SUPPLEMENTAL INFORMATION

Re: Applicant: Samoa Pacific Group
Case Number: FMS-13-003, PDP-13-001
APNs: 401-031-055, 401-031-070

Conditions of Approval for the Samoa Pacific Group Final Map Subdivision

RE: SUBDIVISION REQUIREMENTS - IN THE MATTER OF THE APPLICATION OF SAMOA PACIFIC GROUP, APN 401-031-055 and -070, APPS # 8827 FOR APPROVAL OF A TENTATIVE MAP, CONSISTING OF ±200 ACRES INTO 333 LOTS

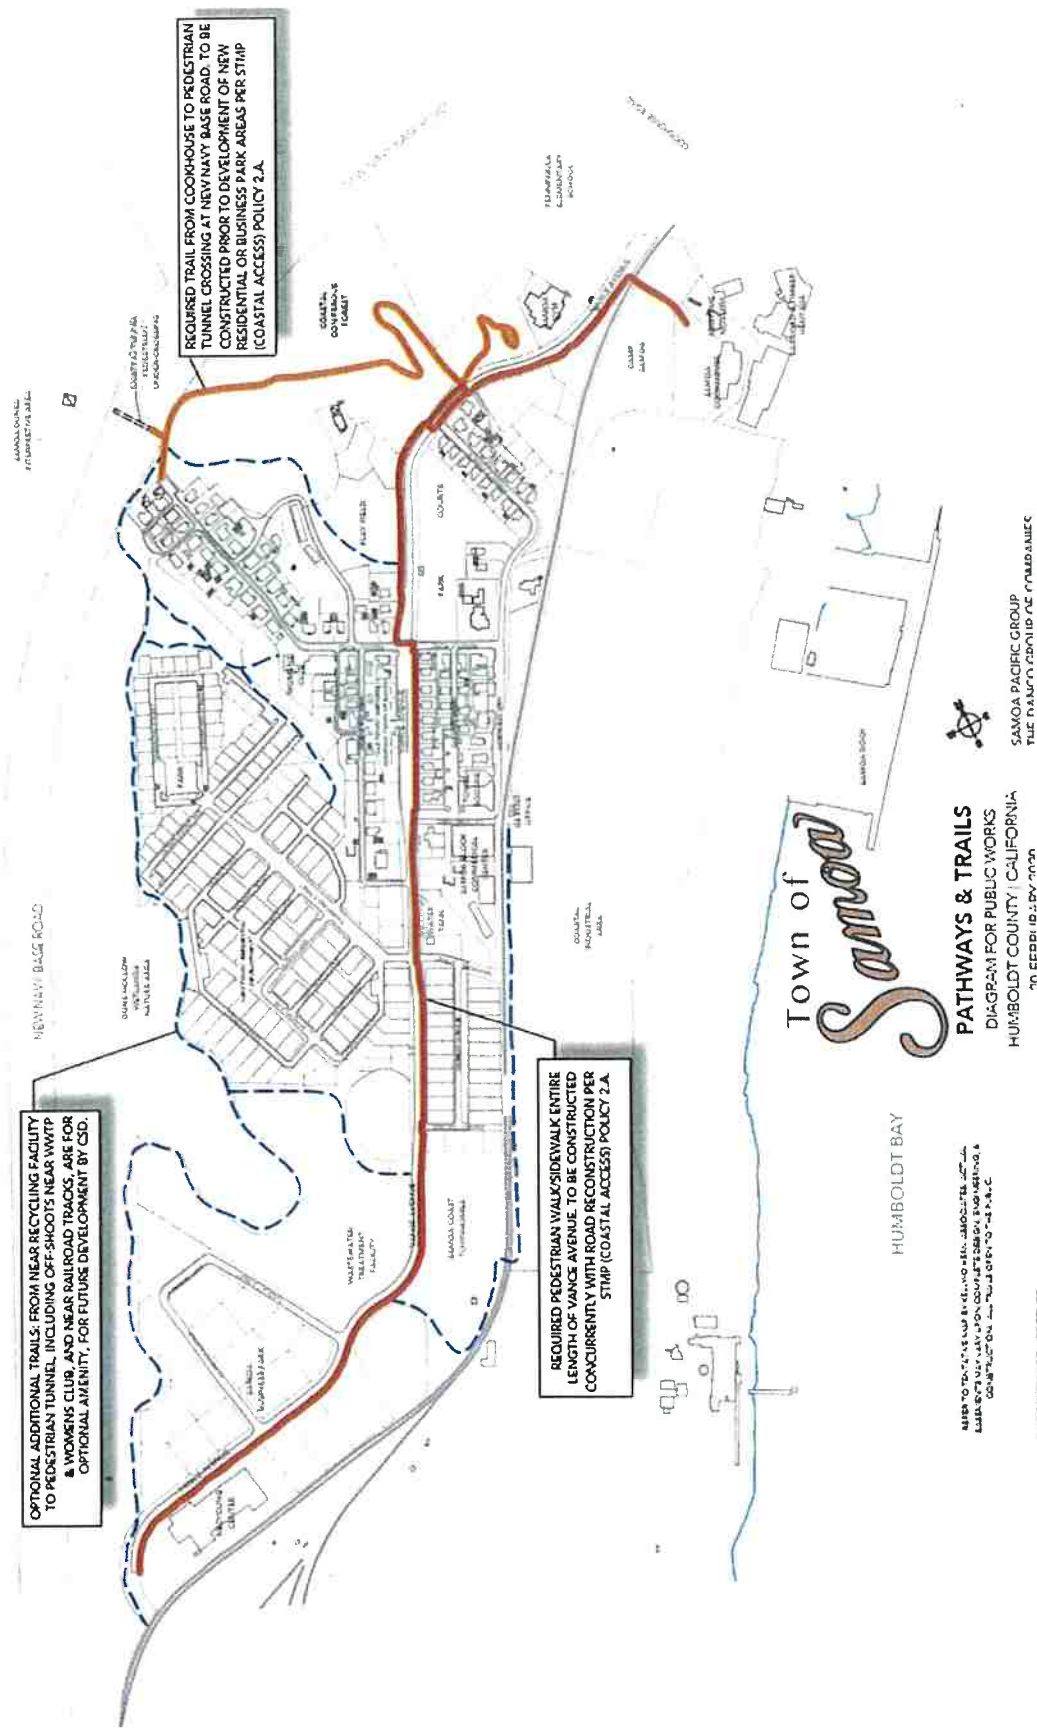
If the optional trail segment near Lot 79 is constructed, then the trail shall be extended to Sunset Avenue.

The entire trail network (orange lines) shall be completed and opened to the public prior to the commencement of development (issue of building permits) within either the business park area or the new residential areas.

Note: the pedestrian facilities (red lines) along Vance Avenue are to be constructed at the same time that Vance Avenue is constructed.

Above: Diagram showing the realignment of the superseded portion of Vance Avenue

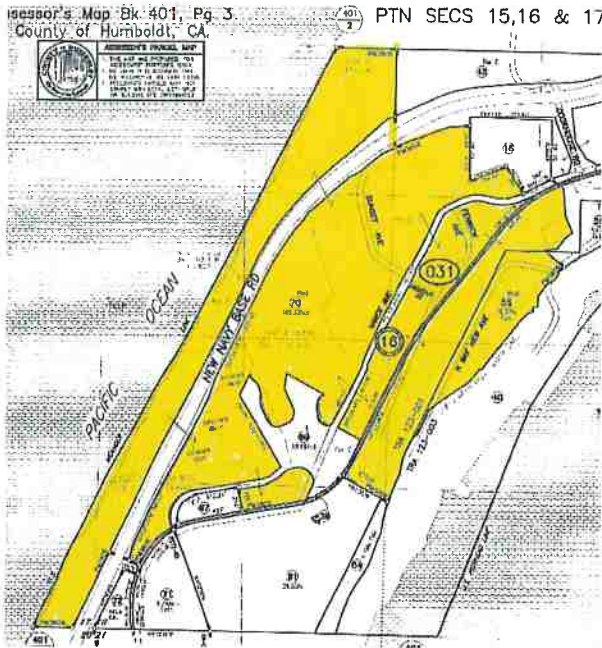
MILWAUKEE AVENUE – VANCE REALIGNMENT: The proposed project includes the realignment of Vance Avenue at the southerly end of the project. The realigned road is called Milwaukee Avenue. No improvements are being required in the superseded portion of Vance Avenue other than obliteration for the unused portion.

Above: Phasing Map (Sheet 2 of the tentative map).

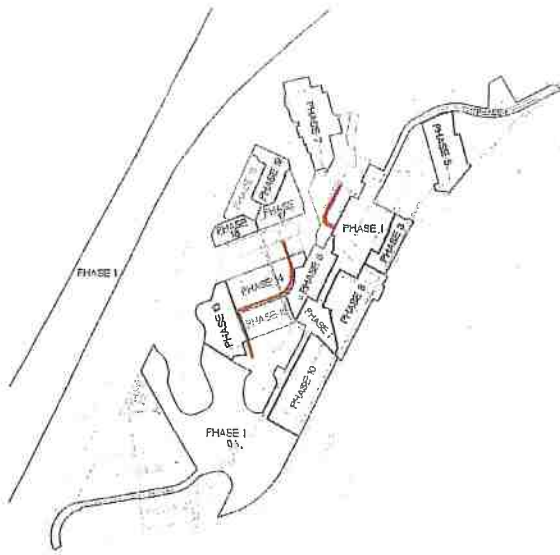
OFF-SITE IMPROVEMENTS: The Department's subdivision requirements include off-site improvements on APN 401-031-069. This property is labeled as "not a part of this subdivision" on sheet 1 of the tentative map. It is shown as "Phase 1" on the phasing map on sheet 2 of the tentative map.

PHASING MAP: The phasing map needs to be updated so that all of the land within the proposed subdivision falls into a phase.

Above: Hammond Street Segments

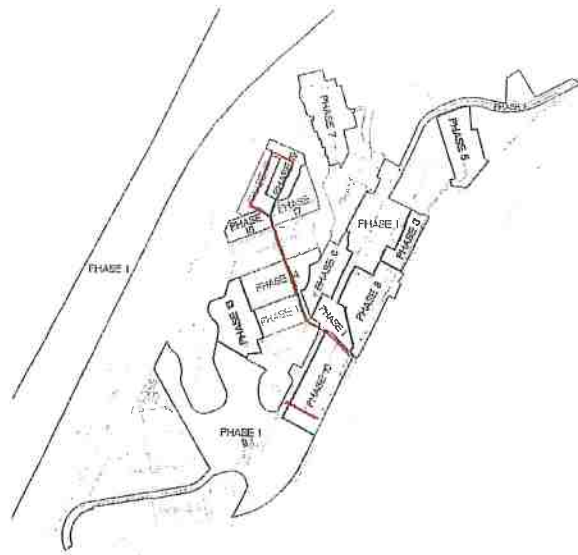
ROAD NAMES: Hammond Street and Murphy Avenue both have multiple segments. This should be reviewed during the street naming process.
